Subject: Re: WRITTEN SUBMISSION Vien Van Luong & Uyen Doan Le: LETTER OF OBJECTION 231 Whale Beach Road Whale Beach 2107 REV 2021/0034

231 Whale Beach Road Whale Beach 2107

REV 2021/0034

Section 8.2(1A) Review of Determination - Review of Determination of Application DA2020/0442 for demolition works and construction of a Mixed-Use Development comprising Shop Top Housing and retail premises, with associated carparking, landscaping and strata subdivision

Marked-up Roof Plan: Zone in excess of 8.5m building height: the excessive height above 8.5m is not 'minor' and fails LEP 4.3 2D [a], and fails the objectives LEP 4.3 [1] [a] desired character of locality, [b] compatible with neighbours, [c] overshadowing, and [d] view.

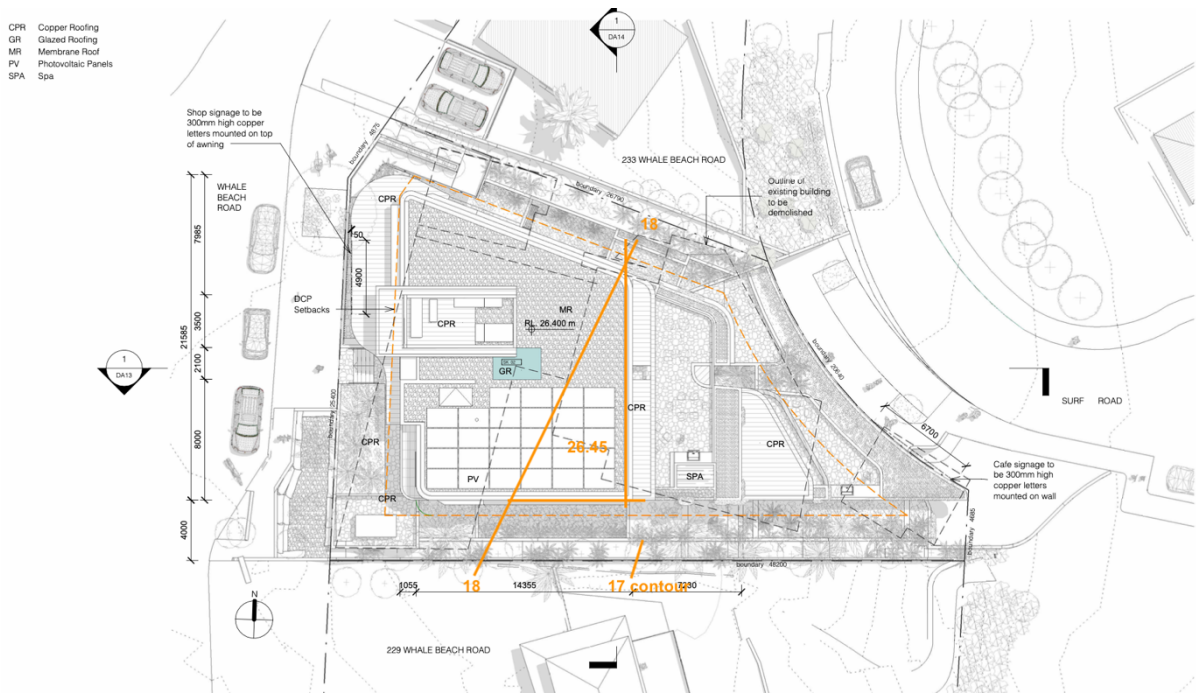
We are disturbed to find a misrepresentation of Heights of Buildings with the *envelope blankets* clearly not aligning with the Registered Surveyors spot levels on the survey.

The Building Height is 9.5m, representing a 12% non-compliance to the 8.5m height. No variation has been sort under Clause 4.6.

The south-east corner of the Level 4 is positioned well above the 8.5m building height, contrary to the Applicants drawings. The excessive height extends along the southern boundary at Level 4 by up to 8m in length, and extends across the entire eastern 16m edge of the proposed roof.

The Registered Surveyors drawings show the 17m contour and a multitude of spot levels between 17m and 18m along the proposed development's southern flank.

The Applicants Height Blanket drawings are unfortunately false and misleading.

The excessive roof zone above 8.5m is a triangular section covering an area of c 65sqm of the south-east corner of Level 4. It is this zone that we contend is unacceptable.

We contend that the excessive height above 8.5m is not 'minor' and **fails LEP 4.3 2D [a]**, and fails the objectives **LEP 4.3 [1] [a] desired character of locality, [b] compatible with neighbours, [c] overshadowing, and [d] view.**

1. Lower the entire built form by 1m. Proposed south-east corner of the roof, sits adjacent to the RL 17.0 Contour. Reduce the Roof Parapet to RL 25.5 to maintain 8.5m building height. Alternatively remove the non-compliant zone above 8.5m building height by greater terracing and a reduced upper level floor plate.

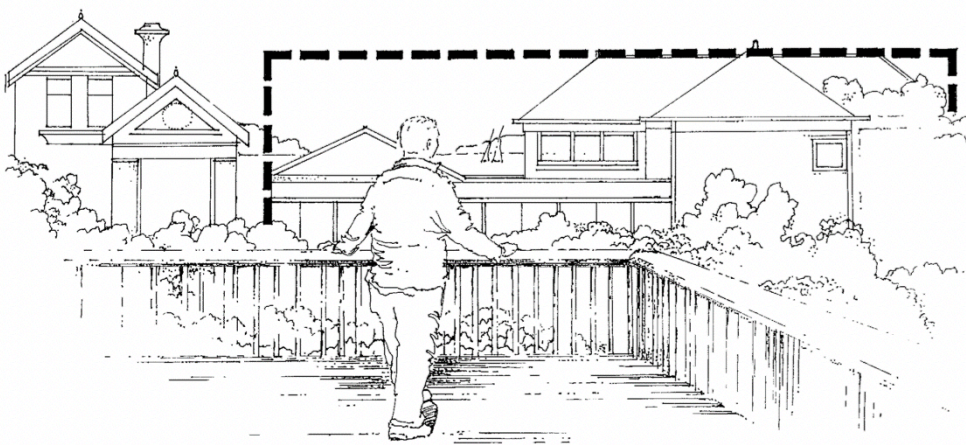
As the proposed development does not comply with outcomes and controls, that are the most relevant to visual impacts, greater weight would be attributed to the effects caused.

In our opinion the extent of view loss considered to be **moderate**, in relation to the views from our living rooms and living room deck of our dwelling, particularly to the east. The view is from a location from which it would be reasonable to expect that the existing view, particularly of the water could be retained especially in the context of a development that does not comply with outcomes and controls.
